Environmental Management & Construction Plan - Notice of Minor Change

Project:	Alle-Catt - NY Wind Project	Case #:	001}	
Location	Allegany, Cattaraugus, and Wyoming County, NY	Change #:	15	
Applicable Certificate	Article 10			
Reference Drawing/Location of Change:	C-135, C-140, C207			
Features Changed: C135- Turn improvement shift directly north C140-Turn improvement radius shift C207-Alternate temporary access. Ag. and Markets Guidelines and Standards will apply to any agricultural impact changes.				
Change Impacts/Benefits	Yes	No	N/A	Description/Notes
Additional Ground Disturbance	✓			C207 requires additional agricultural impacts
Expansion of LOD's		✓		C207 requires additional LOD to work around landowner concrete stormwater apron
Additional Clearing		✓		
Other Impact		✓		
Mitigate/Eliminate impact to other area(s)		✓		
Mitigate/Eliminate impact to wetland(s)		✓		
Mitigate/Eliminate disturbance in other area(s)		✓		
Other Benefit		✓		
Landowner approval (if necessary)	✓

DPS Written Approval By:		
Pages/Pictures/Drawings Attached (Quantity and Description): 1. Redline C135 2. Proposed C135 3. Redline C140 4. Proposed C140 5. Redline C207 6. Proposed C207

DRAWING NO.
C-207

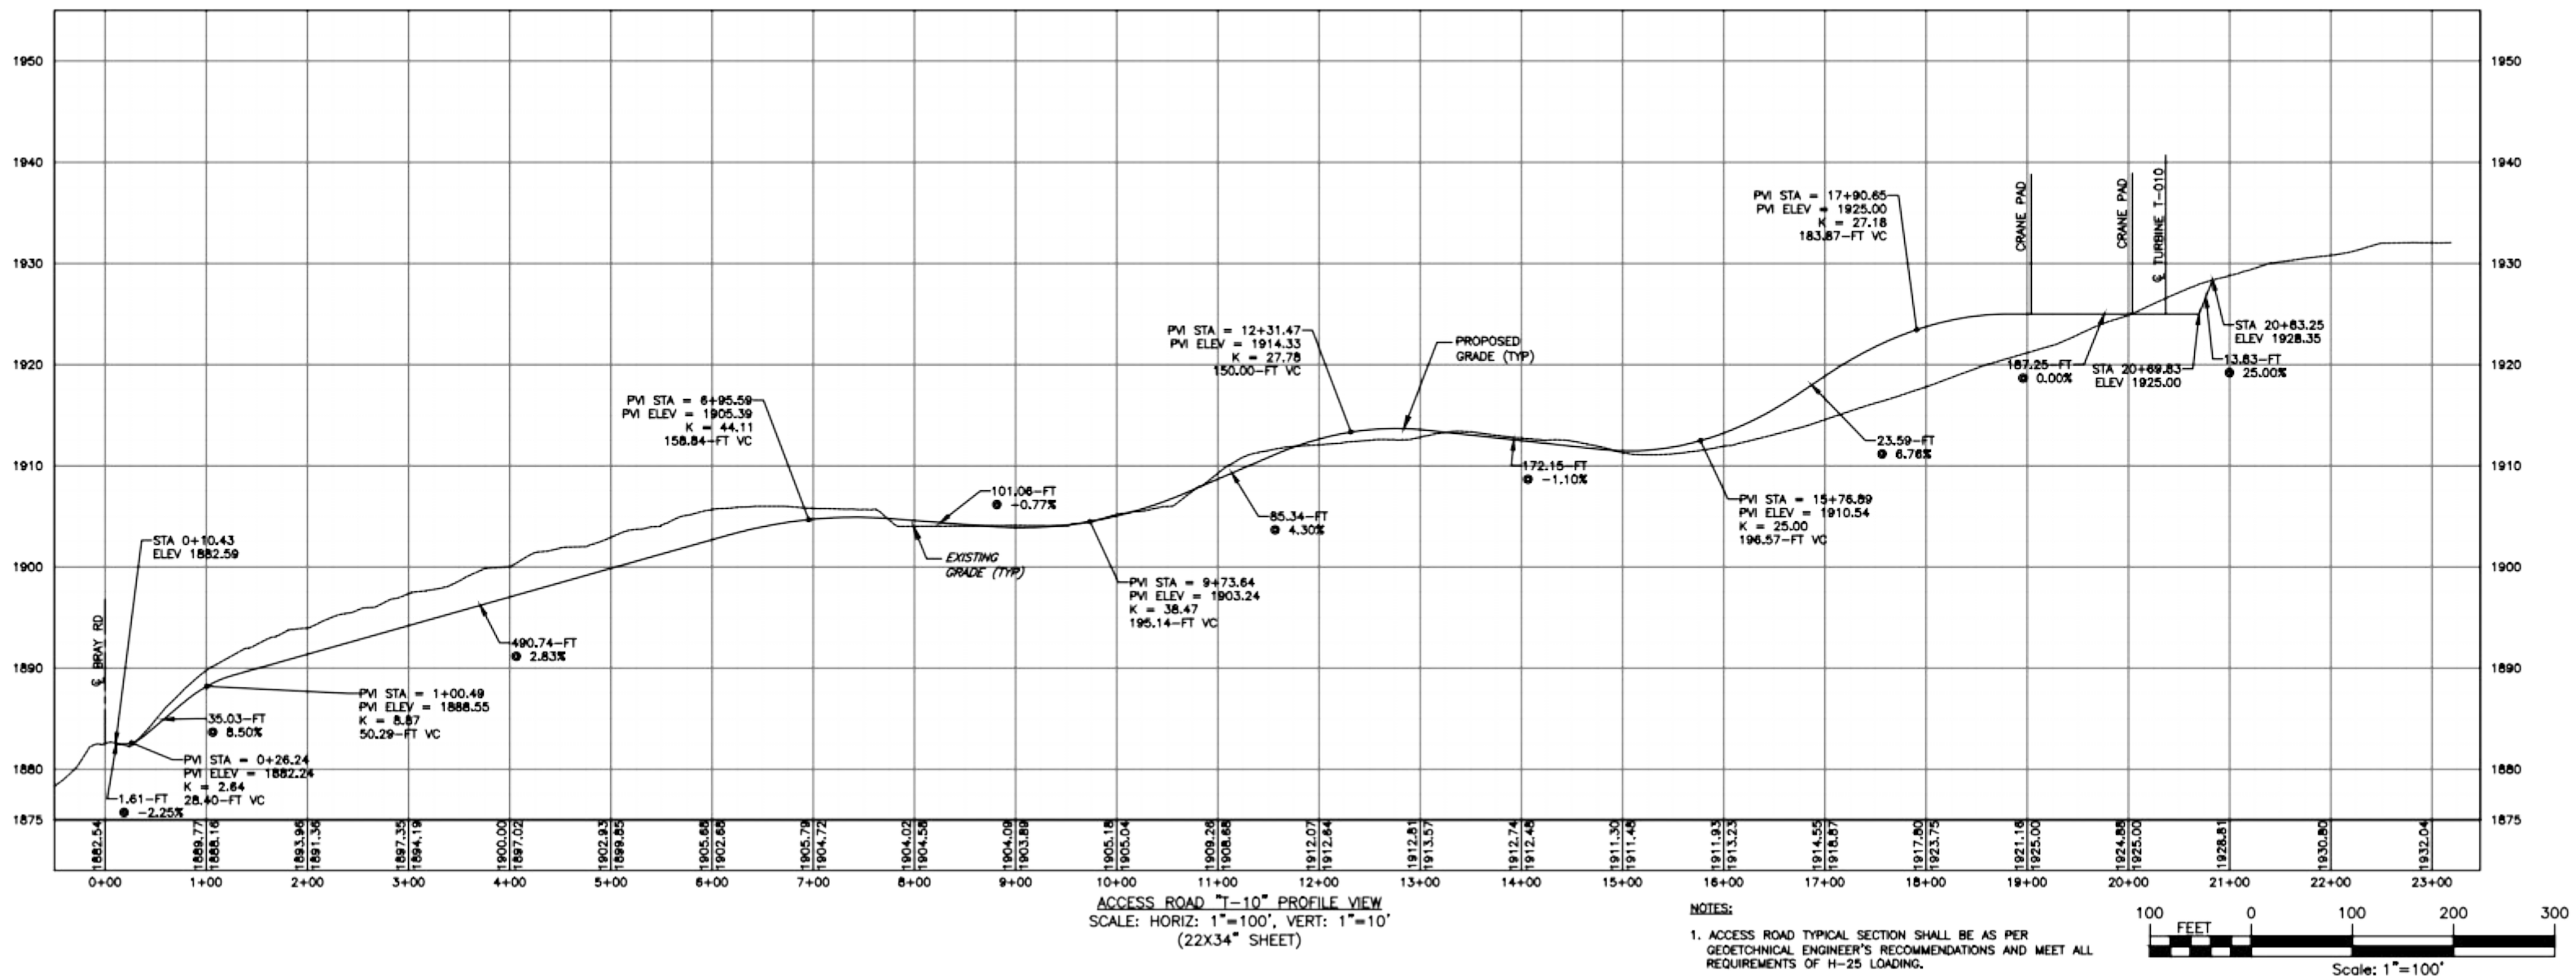
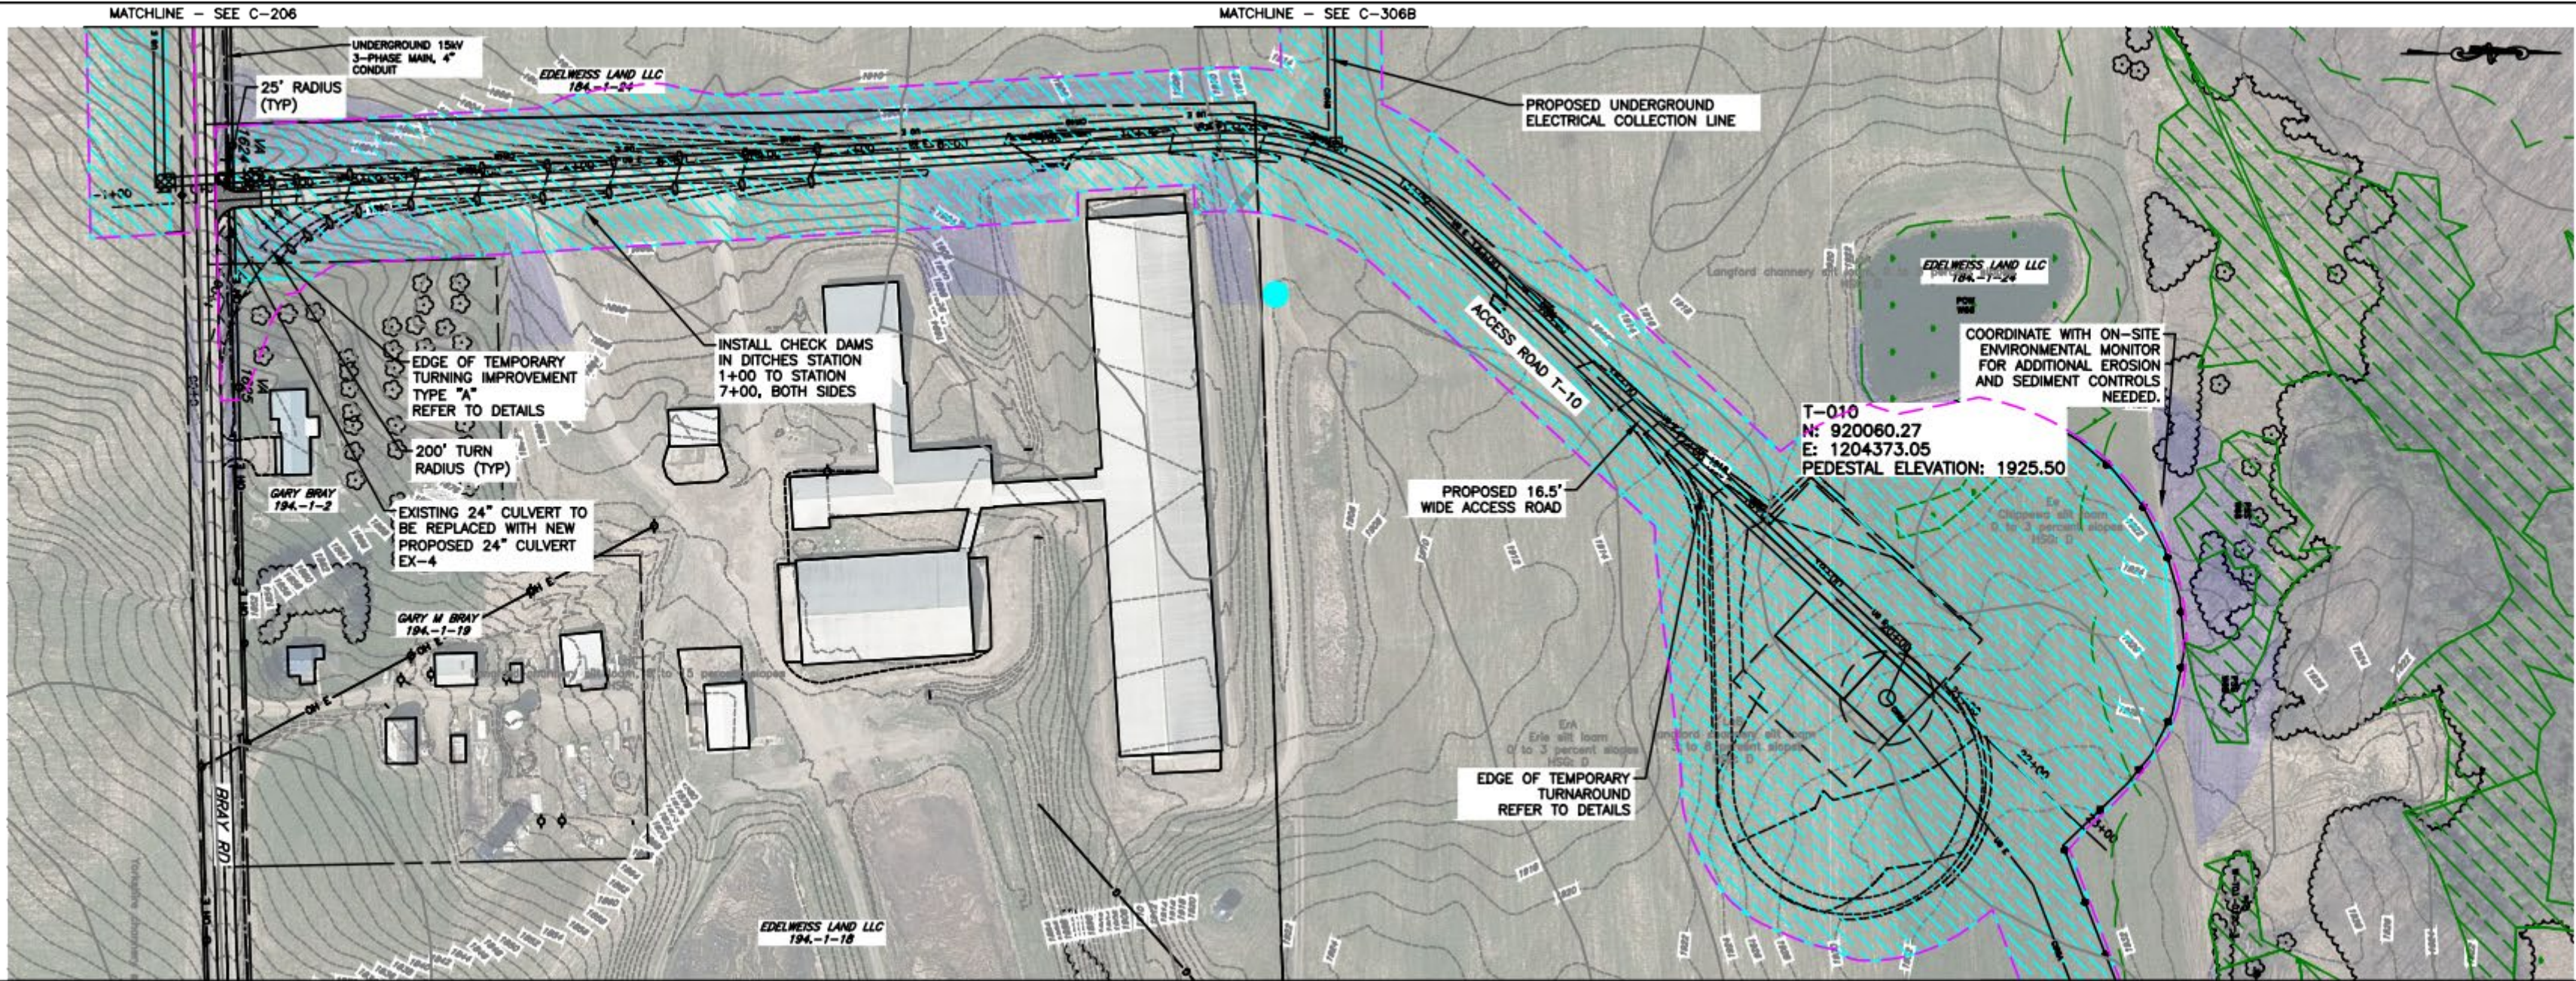
Rationale for Change: C135-There is an existing elliptical Reinforced Concrete Pipe (RCP) 75" W x 48"H culvert crossing Laidlaw Rd. This shift will eliminate the need to remove/damage existing infrastructure. C140- The transportation company has recommended the radius decrease for deliveries at this location. C207- At the entrance to T-10 the landowner installed a concrete apron that ties into Bray Road and runs approximately 50' into the proposed access road. This infrastructure is in the way of the proposed entrance as approved.				
Approvals	Name (Entity)		Date	
Initiated By:	Ray Yorks		9/30/2025	
Invenergy CM/PM Approval:				
DPS Verbal Approval By:

DRAWING NO.
C-207

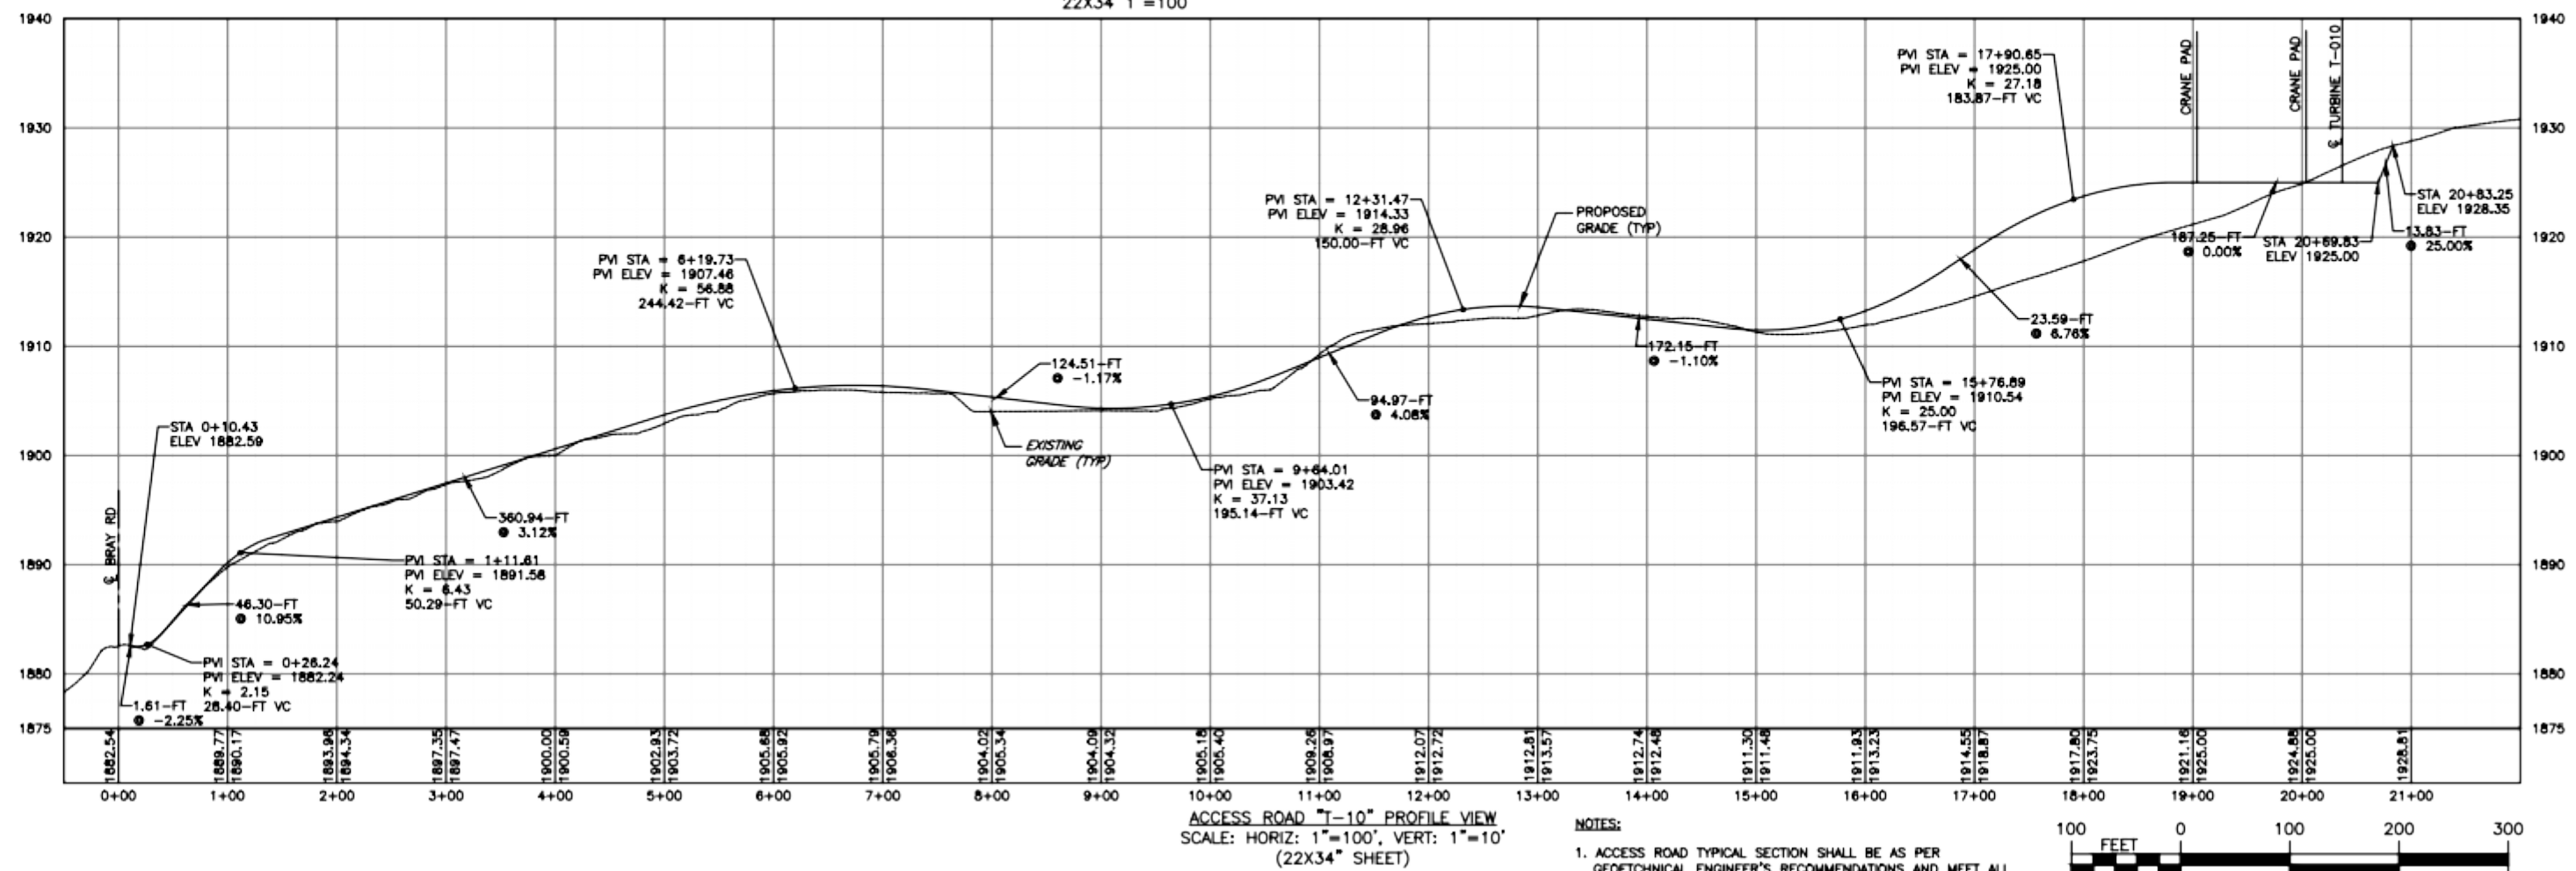
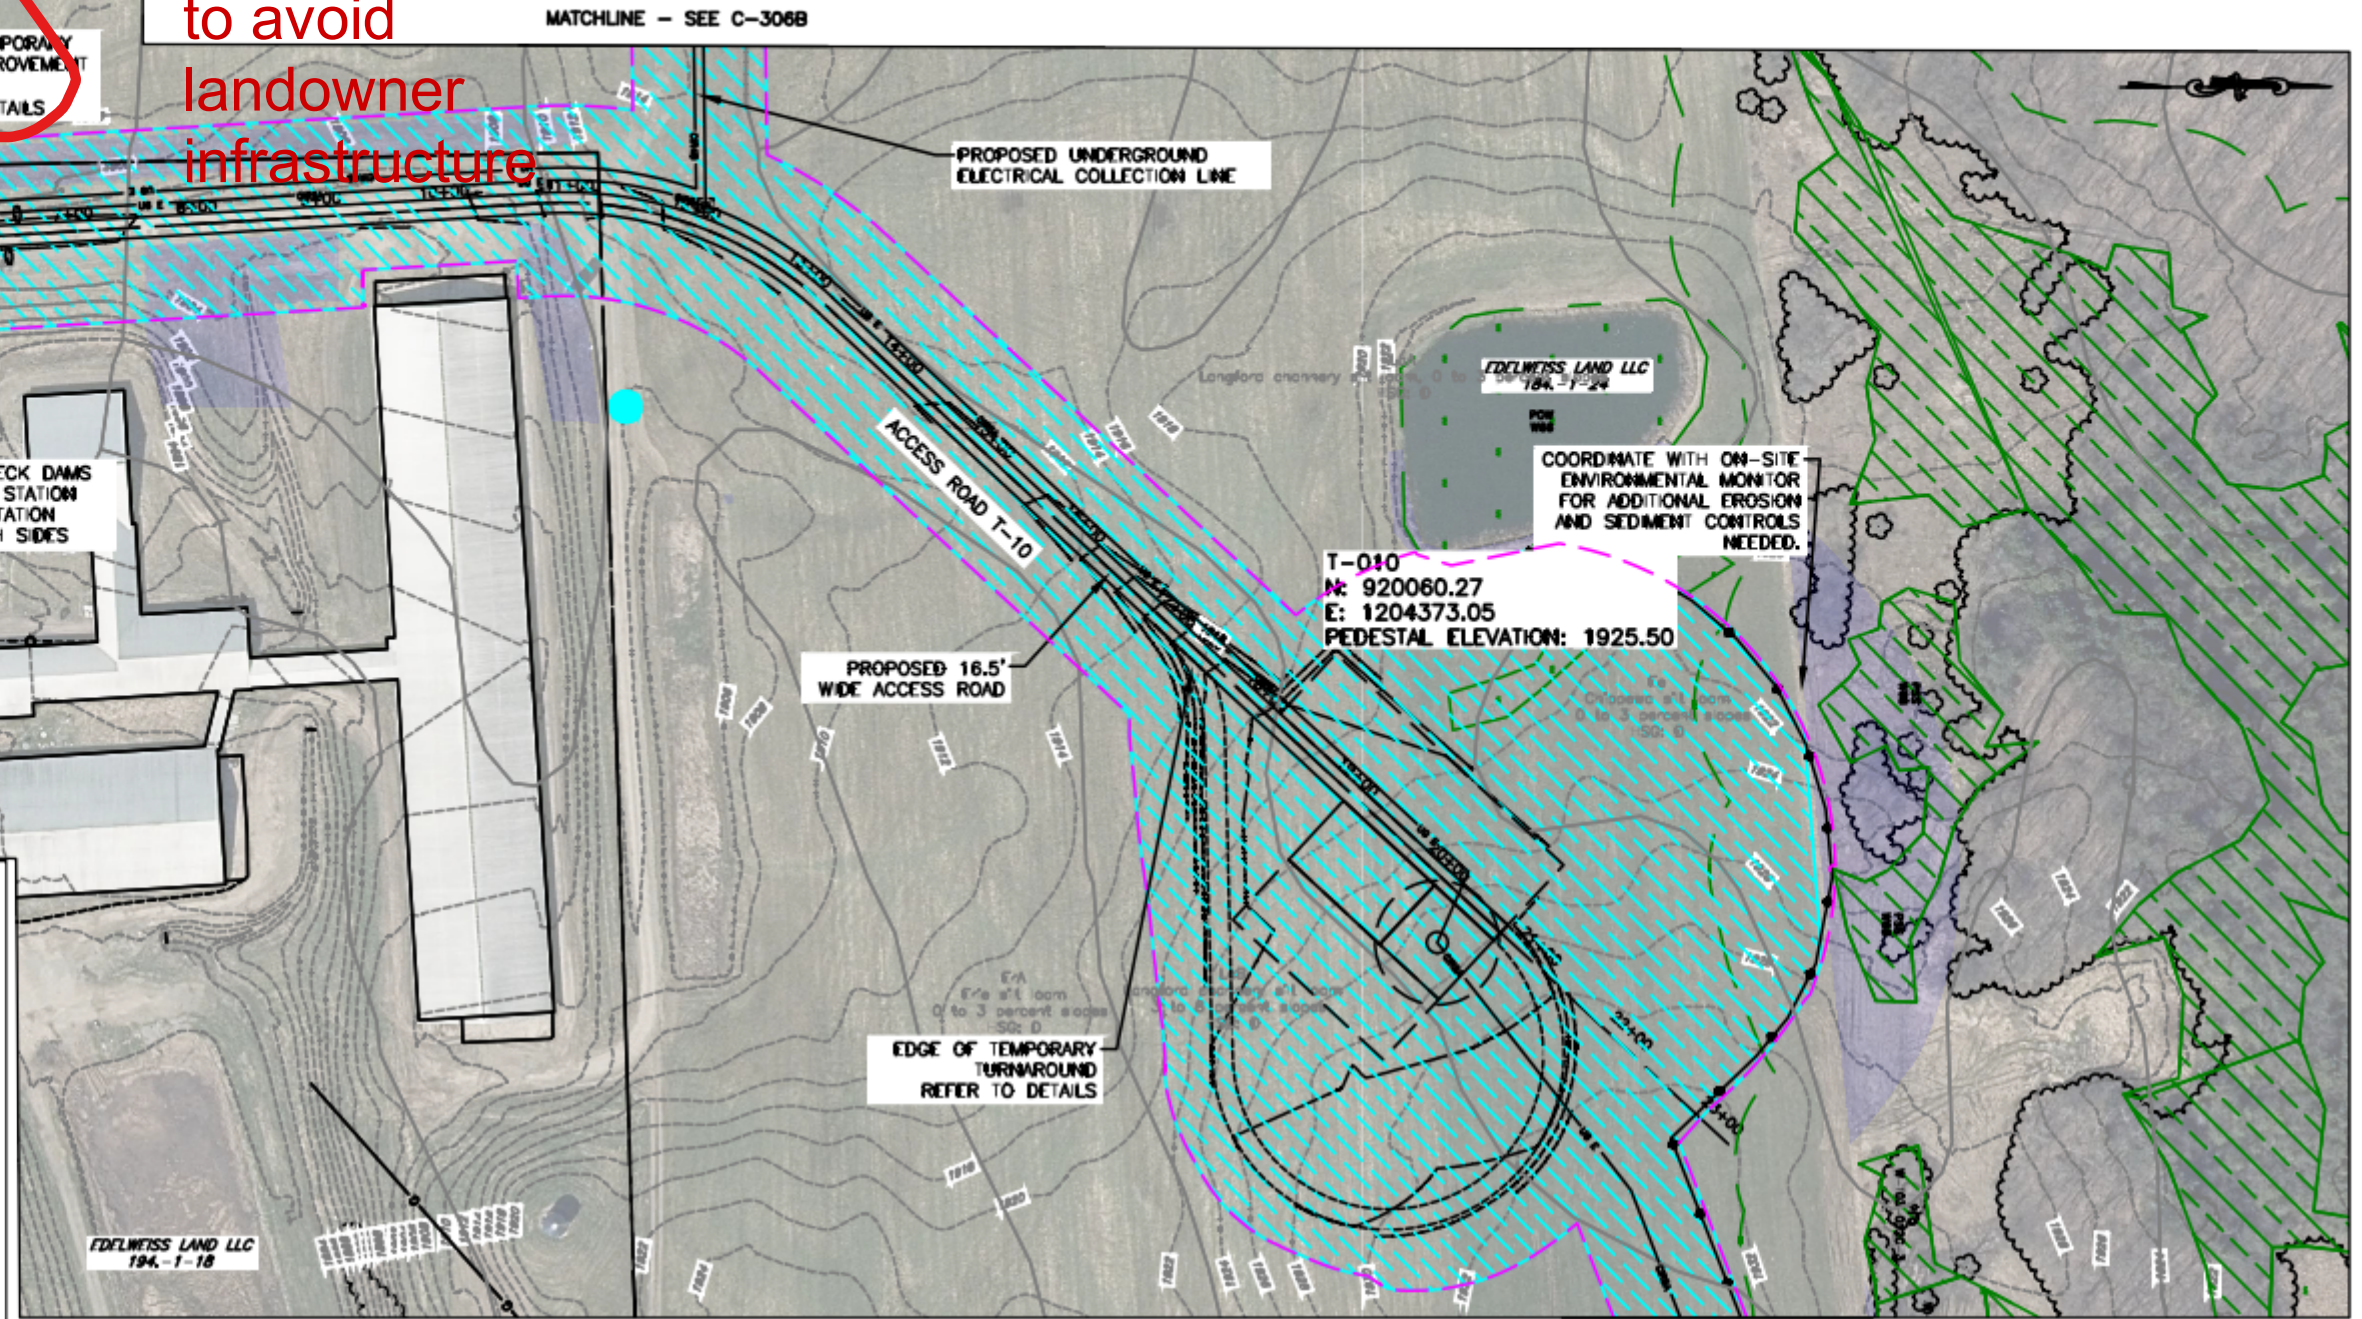
Additional
temp access
to avoid
landowner
infrastructure
